File No. LDA07-0484

RE: Tentative plan of subdivision to create 51 single-detached lots and 74 row-housing lots from a portion of NW 19-52-25-4; located south of Whitemud Drive and east of Winterburn Road (215 Street); **GRANVILLE**

SUBDIVISION CONDITIONS OF APPROVAL MAP

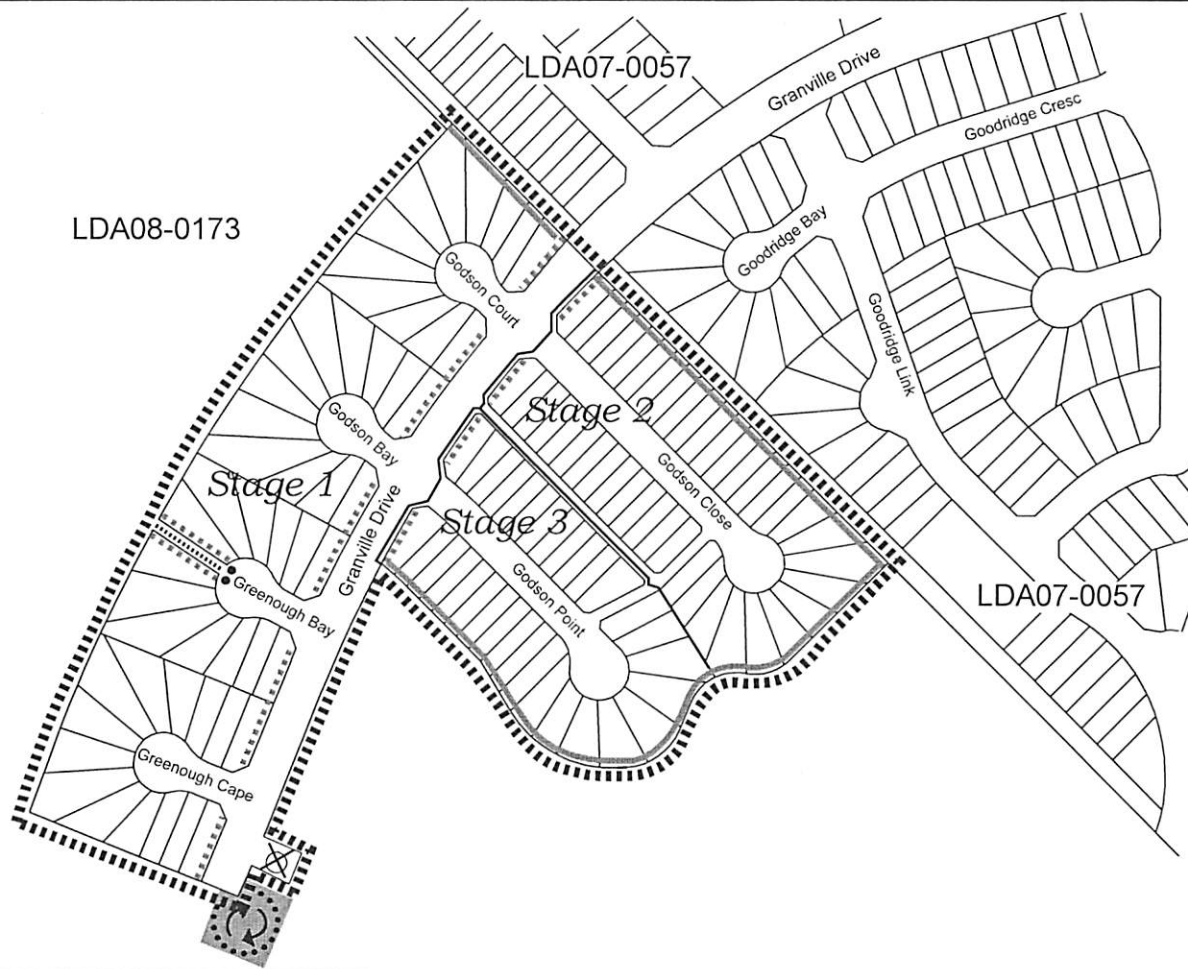
3. that the owner register the walkway as a road right-of-way, as shown on the "Conditions of Approval" map, Enclosure I;
4. that the owner be permitted to register this plan of subdivision in stages, as shown on the "Conditions of Approval" map, Enclosure I, at the discretion of the Chief Subdivision Officer, having regard to the provision of roadways and the logical extension of services;

5. that the owner dedicate a portion of road right-of-way to accommodate the abandoned well site working area to the satisfaction of the Transportation Services, as shown on the "Conditions of Approval" map, Enclosure I; and

7. that the engineering drawings include an offset 17 m radius asphalt-surface temporary transit turnaround with bollards or mini-barriers, to the satisfaction of the Transportation Services in the location shown on the "Conditions of Approval" map, Enclosure I;

8. that the owner construct all fences positioned wholly on privately owned lands to the satisfaction of the City of Edmonton in the locations shown on the "Conditions of Approval" map, Enclosure I; and
